## **NUCLEAR REGULATORY COMMISSION**

Title:                   Advisory Committee on Reactor Safeguards  
                              Reliability and PRA Subcommittee

Date:                  Monday, July 22, 2013

The Subcommittee will hear the staff and industry's response to the SRM on SECY-12-0081, Risk-Informed regulatory framework for new reactors.

# Relative Risk Approach – ACRS Recommendation

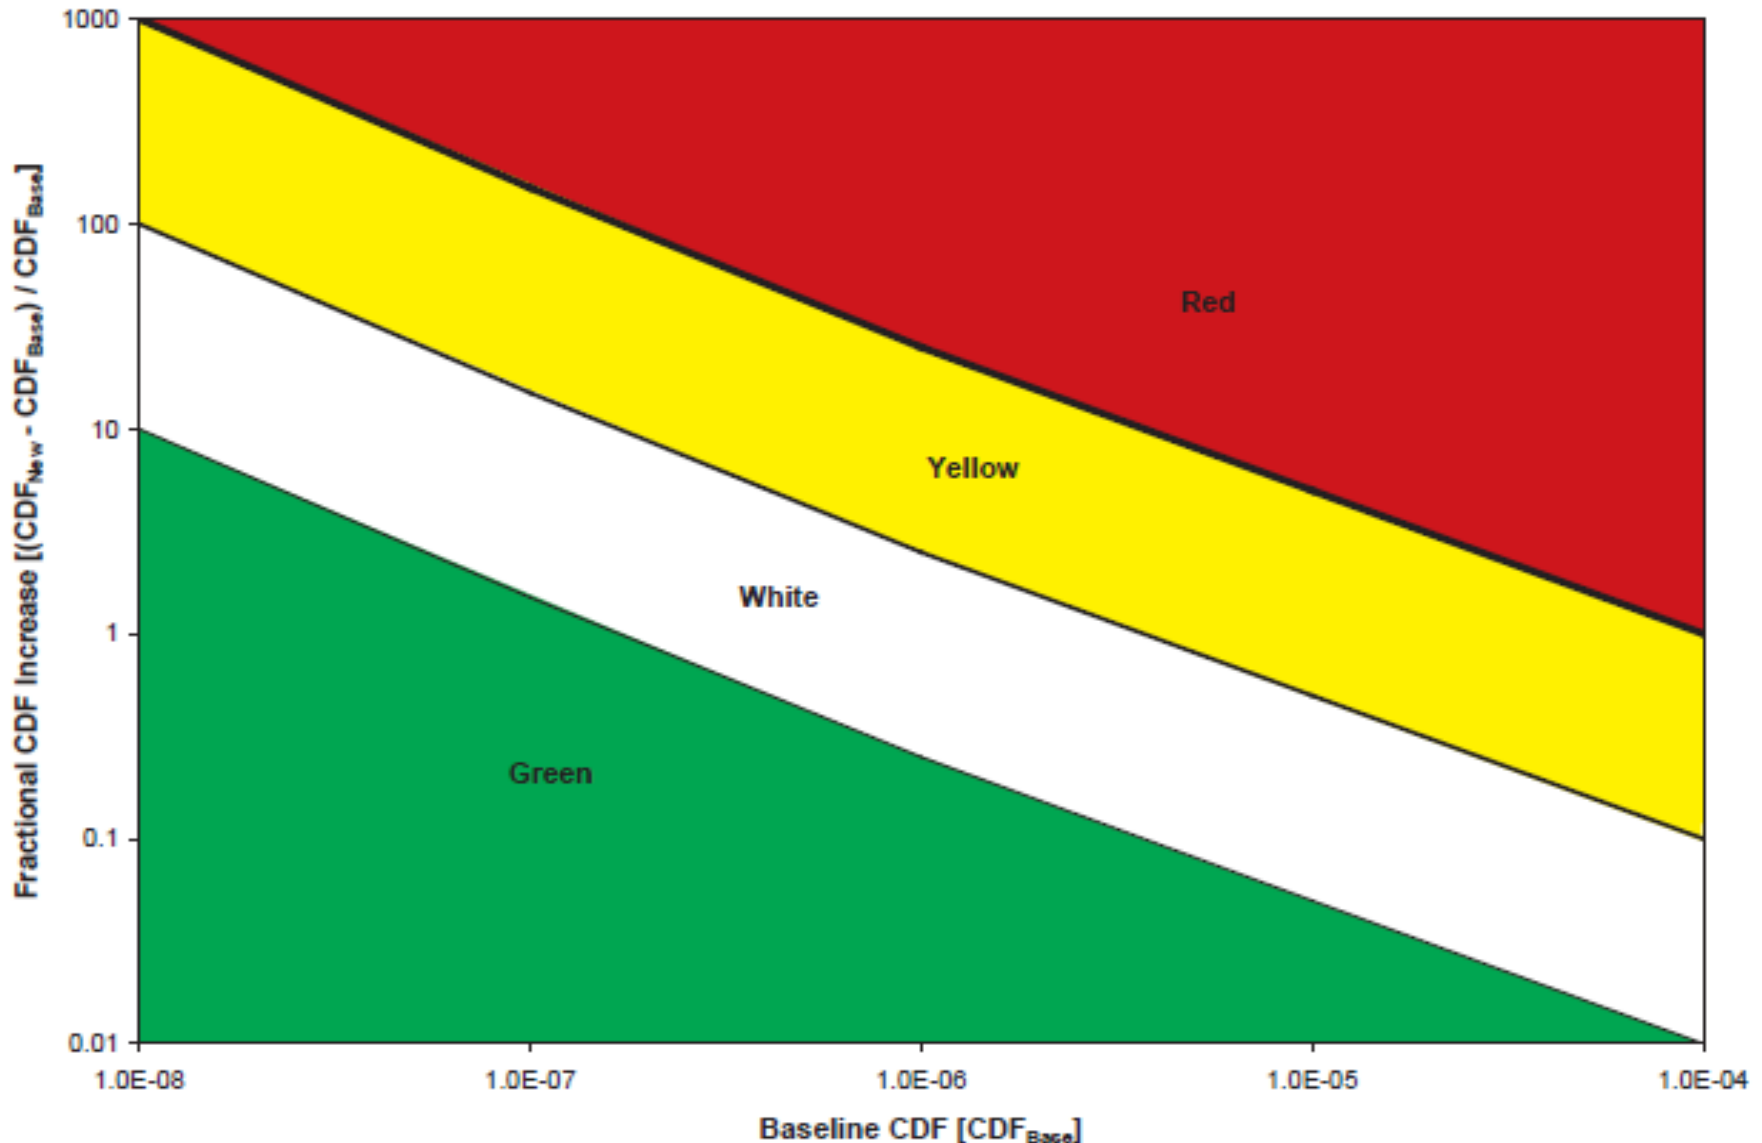
11 This is the conceptual draft that the ACRS  
12 proposed in its letter dated April 26th, 2012, and this  
13 graph demonstrates one proposed method that could be  
14 used to implement a relative risk approach. This graph  
15 has a baseline CDF on the X-axis and a fractional CDF  
16 increase divided by the baseline CDF, or a percent change  
17 in CDF on the Y-axis.

18 I won't go into too much detail since this  
19 graph came from the ACRS, but I will say briefly that  
20 the general concept behind the relative risk approach  
21 is that the lower the baseline CDF value for a plant,  
22 the higher percent change that would be allowed for a  
23 finding before it would be greater than green, and the  
24 converse is also true, that the higher the baseline CDF,  
25 the lower percent change allowed before a finding would

# Relative Risk Approach – ACRS Recommendation Converted to $\Delta$ CDF (y-axis)

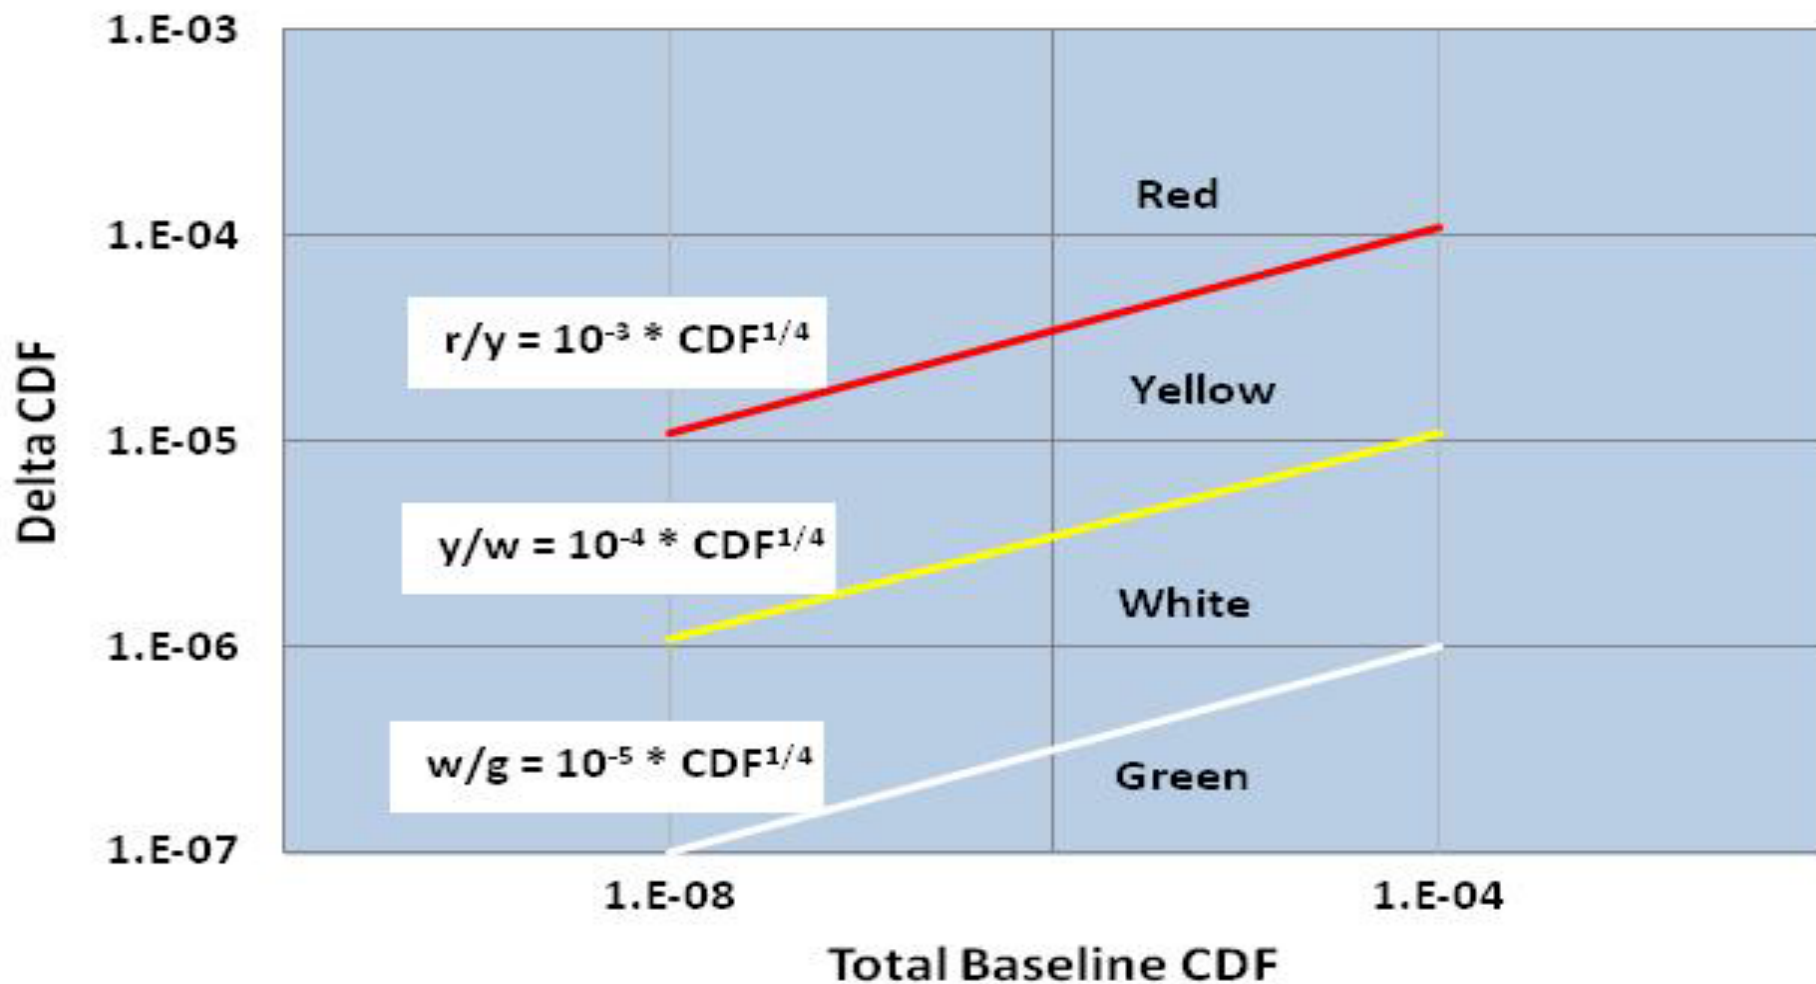
2 And moving on to slide 42, we, the staff,  
3 converted the ACRS graph on slide 4 to have a delta CDF  
4 on the Y-axis instead of a percent change. However,  
5 I would like to point out that the thresholds are the  
6 same and yield the same results. This can be seen by  
7 simply looking at a baseline CDF of 10 to the minus 4  
8 per year on this graph. So, you look at this point right  
9 here.

10 The threshold to get to a white finding is  
11 a delta CDF of 10 to the minus 6 per year, which is a  
12 1-percent change. And so, looking back at slide 41,  
13 you can kind of do a sanity check, and this is, indeed,  
14 a 1-percent change at 10 to the minus 4 when you look  
15 at .01 right here.

16 And also, if you look at the far left of  
17 the graph, a point with a baseline CDF value of 10 to  
18 the minus 8 per year. The threshold to get to a white  
19 finding is a 10-percent change, which is a delta CDF  
20 of 10 to the minus 7 per year. And looking forward onto  
21 slide 42, the delta CDF value for a 10 to the minus 8  
22 plant per year is, indeed, 10 to the minus 7 delta CDF.

# Relative Risk Approach

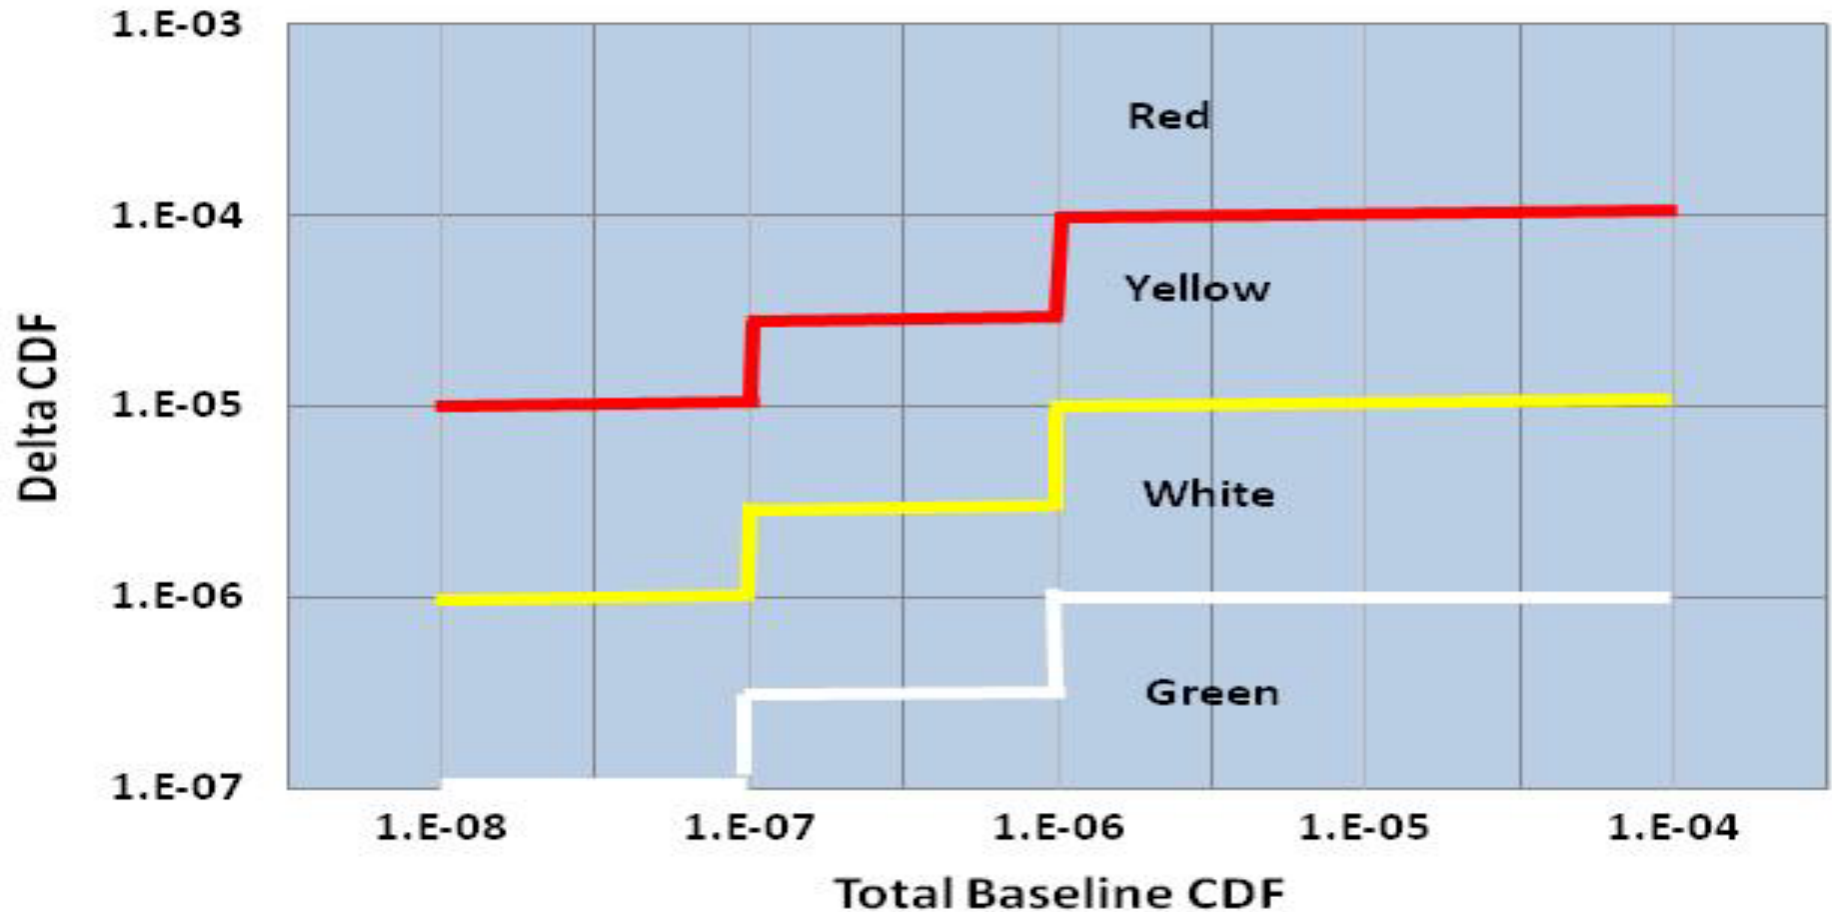
10          So, now to describe this graph a little,  
11       the concept uses a total baseline CDF on the X-axis and  
12       delta CDF on the Y-axis for a plant to determine the  
13       significance of an inspection finding using the slope  
14       lines for the thresholds.

15          The concept behind this approach is that  
16       the lower the baseline CDF of a plant, the lower delta  
17       CDF value or a larger fractional change necessary for  
18       increased significance of a finding.

20 MR. POWELL: Okay. And the last point that  
21 I want to make on this slide is that the significance  
22 of a finding would be relative to the baseline CDF value  
23 instead of the current approach of absolute thresholds,  
24 which do not change given a particular plant's baseline  
25 CDF.

# Staircase Thresholds Approach (cont.)

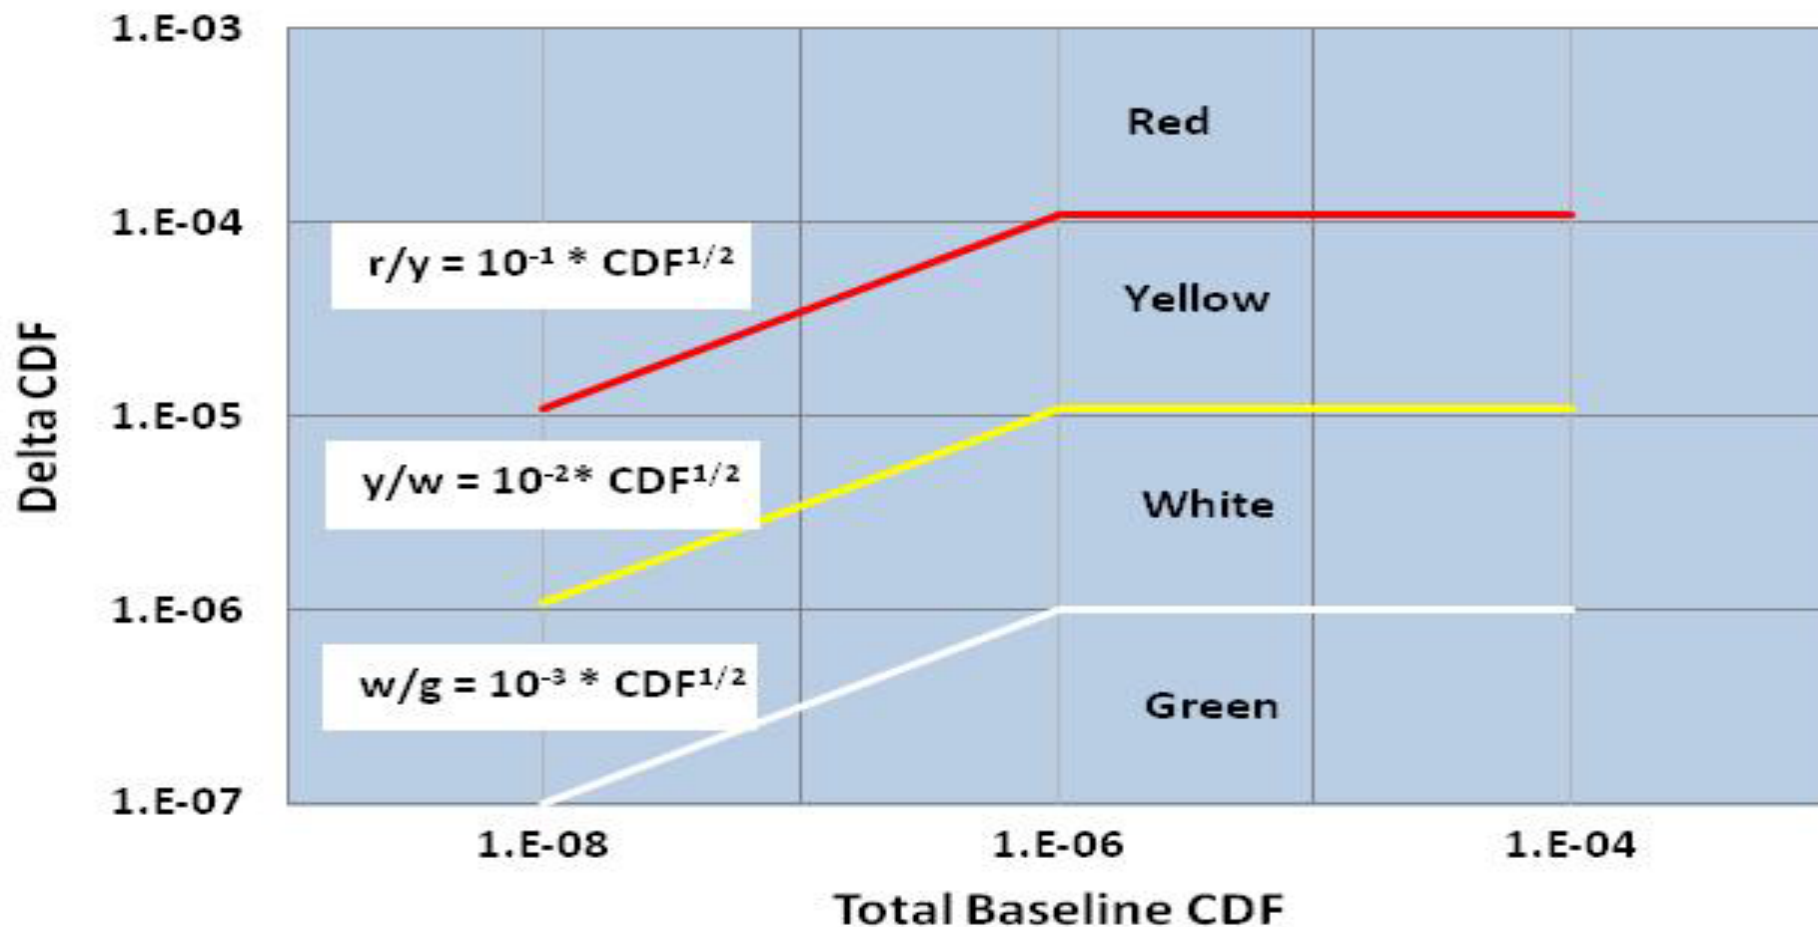
1 CDF on the Y-axis for a plant to determine the significance  
2 of an inspection finding using the staircase lines for  
3 the thresholds.
